3.4 Instrumentation and Control

STD DEP T1 3.4-1 (Figure 3.4a, Figure 3.4b, Figure 3.4c)

Figure 3.4a Safety System Logic and Control (SSLC) ~~Control~~ Interface Diagram

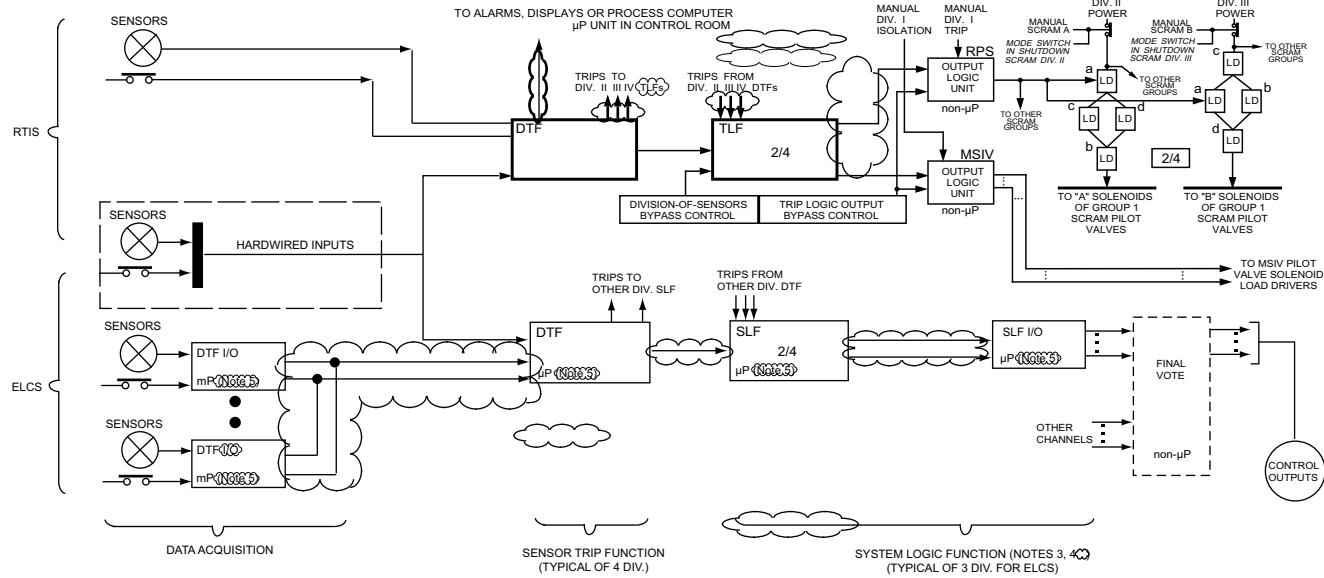
safety-related portions of the Neutron Monitoring System (NMS), the Containment Atmospheric Monitoring System (CAMS) and the radiation monitoring systems. The relationship between SSLC and systems for plant protection is shown in Figure 3.4a.

Figure 3.4b Safety System Logic & Control Block Diagram

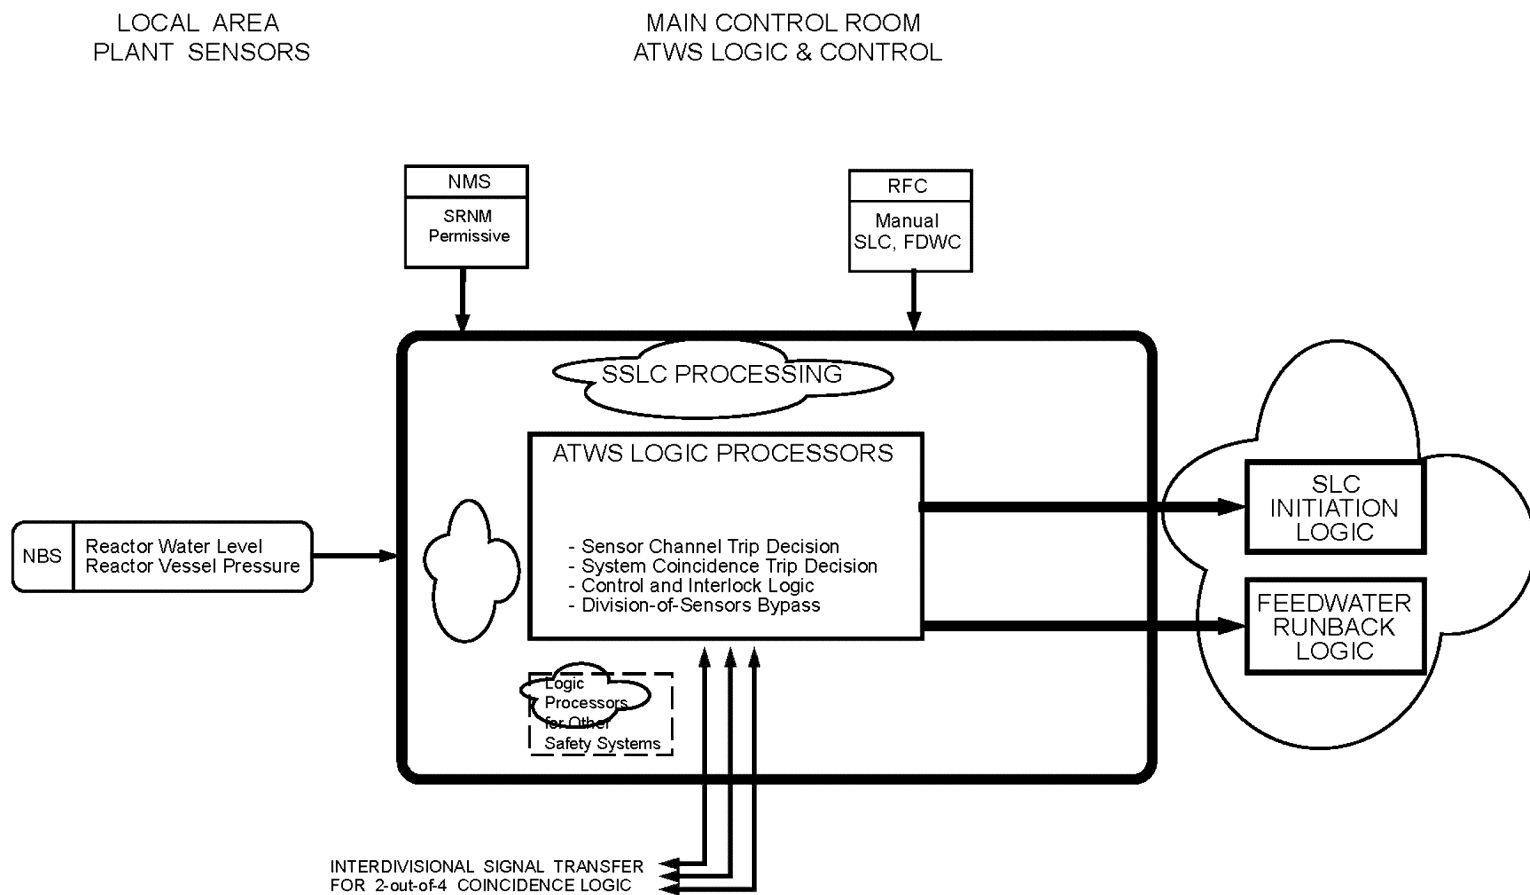
~~The basic hardware functional~~ configuration for one division of SSLC is shown in Figure 3.4b. Each division runs independently (i.e., asynchronously) with respect to the other divisions. The following steps describe the processing sequence and associated function descriptions for incoming sensor signals and outgoing control signals. These steps are performed simultaneously and independently in each of the four divisions:
